DANE COUNTY DEPARTMENT of PUBLIC WORKS, HIGHWAY and TRANSPORTATION

RFB NO. 314037 - ADDENDUM NO. 1

BLUE SHED GAS DETECTION AND VENTILATION

HIGHWAY STORAGE FACILITY

Modify current Sheet M101, Detail [A] as follows:

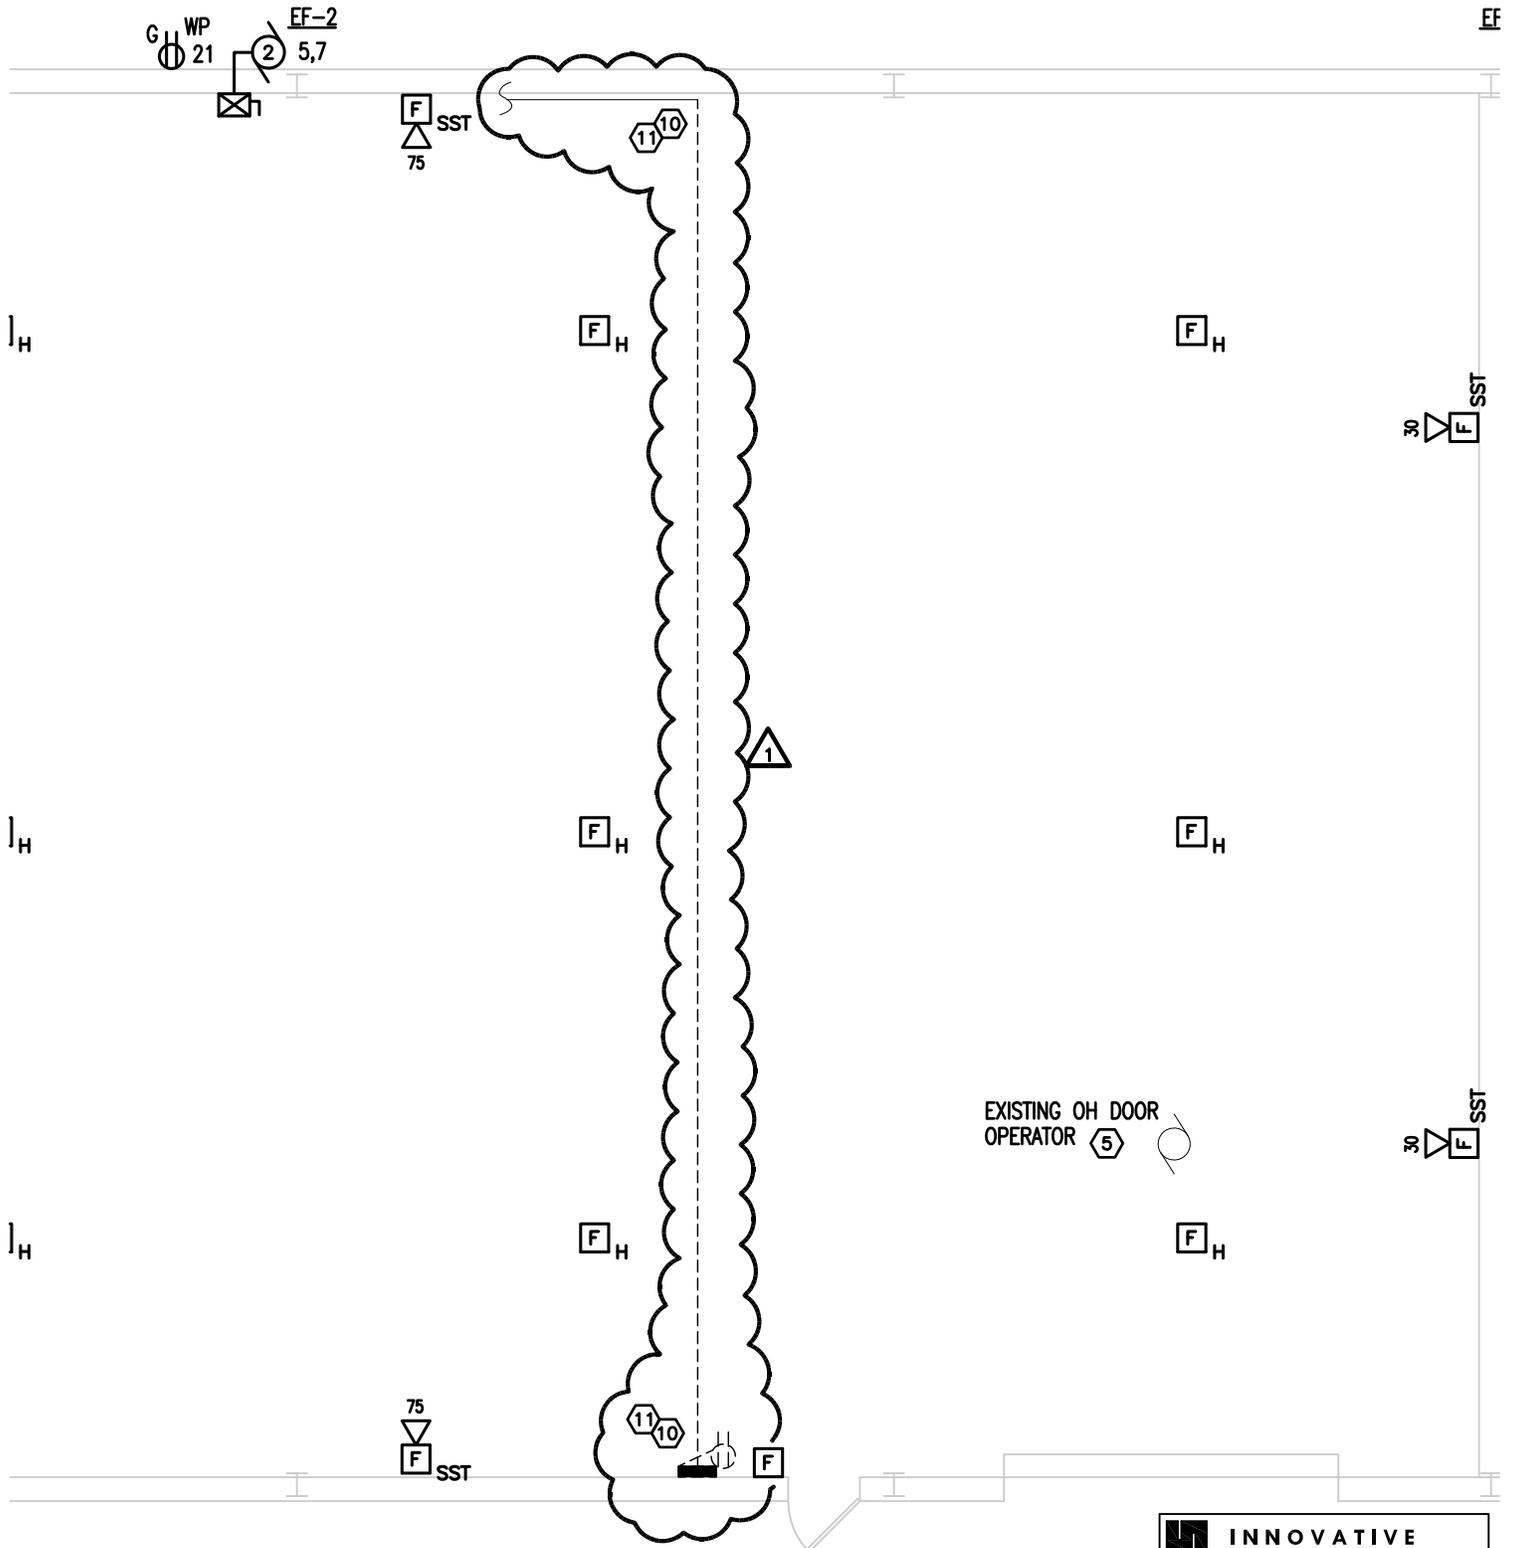
- a) Add the following to the fan schedule notes: “8. EF-9 AND ASSOCIATED DUCTWORK, DETECTION, CONTROL, AND ASSOCIATED ELECTRICAL WORK SHALL BE PROVED AS AN ALTERNATE BID.”
- b) At Mark EF-9 remarks add Note #8.

POWER RISER DIAGRAM – DEMOLITION

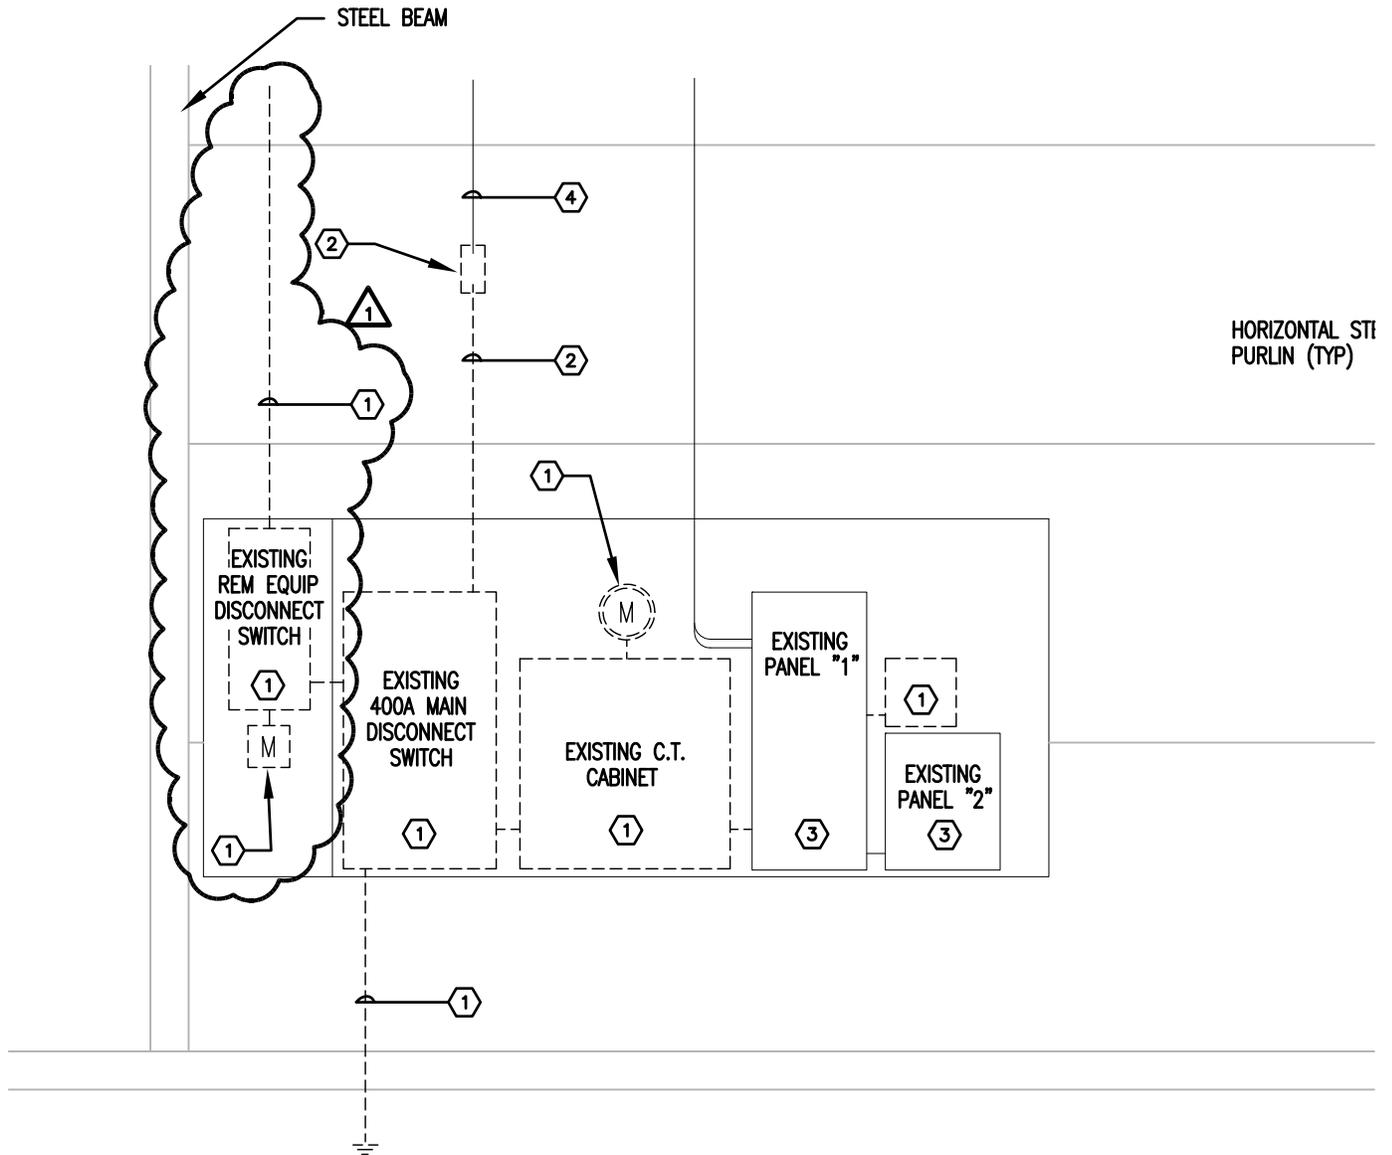
4. Sheet E101

Revise drawing – Refer to attached supplemental sheet “SD2”.
